**Addendum # 8**  
**San Mateo County Harbor District**  
**(Pillar Point Harbor RV Park Restroom and Greenspace Project)**  
**(August 4, 2022)**  
**IFB No.- 2018-08**

Below are our responses to questions and requests for clarifications received as of August 4, 2022. This Addendum corrects the response to Question 7-11 and answers Question 7-12. Additional information has also been added to Response 7-4. New requests for clarifications begin at Questions 8-1 through 8-5.

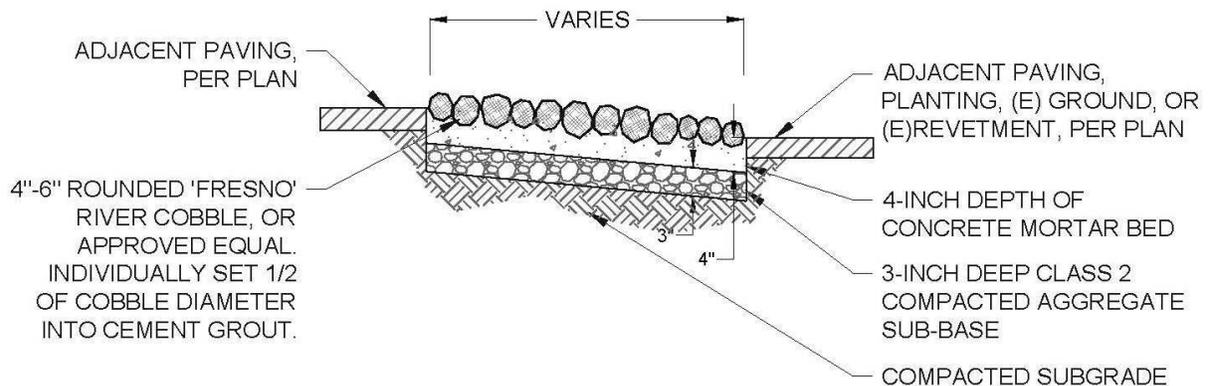
4-20	Schedule calls for Acorn Toilet 1675-W-1 to be 316SS. This product is not available in 316SS. Please advise  A: 304SS is acceptable.	Drawings	P0.1
4-21	Schedule calls for Acorn Urinal 1709HEU-W-1 to be 316 SS. This product is not available in 316SS. Please advise.  A: 304SS is acceptable.	Drawings	P0.1
4-22	Schedule calls for Sloan Products 140 and 141 for flushometers. Note: Sloan 141 is no longer available. Sloan 195 has multiple configurations but appears to be a replacement. Attached are specs for 2 with the correct GPF. Please note both the 195 and the 140 called out on schedule have a rough brass finish. Please advise re:  A: Sloan 195-0.125-5-3/4-LDIM is acceptable	Drawings	P0.1
4-23	Schedule calls for ACO linear drain in 316SS. Drain only available in 304SS. Please advise.  A: 304SS is acceptable.	Drawings	P0.1
4-24	Detail# 5 shows teak board height of 1 3/4" however Detail #11 shows a height of 3 1/2". Please clarify.  A: Detail #5/A5.1 1 3/4" is acceptable.	Drawings	A5.1

**2 CONCRETE WALKWAY**  
Scale = NTS

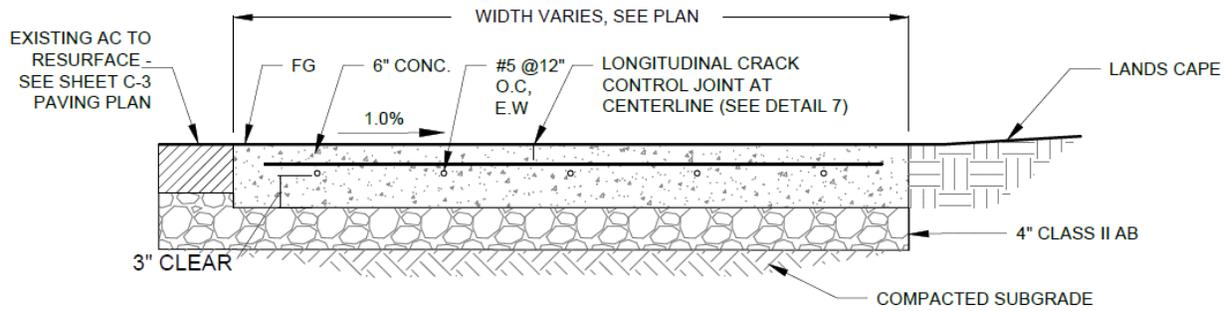
8-1	Please clarify – if Hot Tap Quote in Bid Item #41 “refers to Bid Item #42” and if an approved contractor of Coastal Water District must do hot tapping – which bid line should the hot tapping be included in? A: Two Hot Taps are required and to be paid as part of Bid Item 42 and the tap/meter installer must be approved by CCWD. There is a list provided in the bid documents (Technical Specifications, Appendix A), and CCWD-approved installers have been alerted to this project. Disregard “Hot Tap Required” in Bid Item #41. See attached revised Bid Form.	Bidder Question 7-1	
8-2	In error, I typed “pervious painting” which was interpreted by whoever answered the question to “pervious paving” and then they went on to address pervious “pavers.” My question is about the pervious paving noted specifically on C-6 detail #2. This detail shows “pervious ac parking.” Please provide limits of pervious ac parking. A: The extents of paving are shown on sheet C-3. The paving adjacent to the concrete walkway will be AC resurface. Detail 2, Sheet C-6 has been revised to state “Existing AC to Resurface,” instead of “Pervious AC Parking,” as shown below.	Bidder Question 7-3
